Ku-ring-gai Council Submission

Draft Explanation of Intended Effects Proposed Medium Density Housing Code

Draft Medium Density Design Guide

Department of Planning and Environment
November 2016

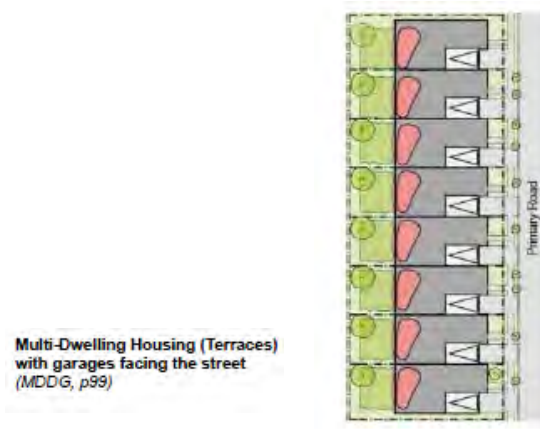
Figure 2-26 taken from Linwood Estate, Honeysuckle, Newcastle is also not representative of the proposed minimum 'Internal Street' reservation as proposed. Measured from SixMaps, the reservation is a min 9m, and it still does not achieve any meaningful landscape. It should be further noted that the image is of a rear lane in the subdivision and that the dwellings actually address either a full street frontage and/or the Hunter River foreshore. Figure 2-26 is proposing less of a building separation, to be the primary streetscape character and address that is proposed by Figure 2-27. This is unacceptable as a primary aspect for any sort of housing.
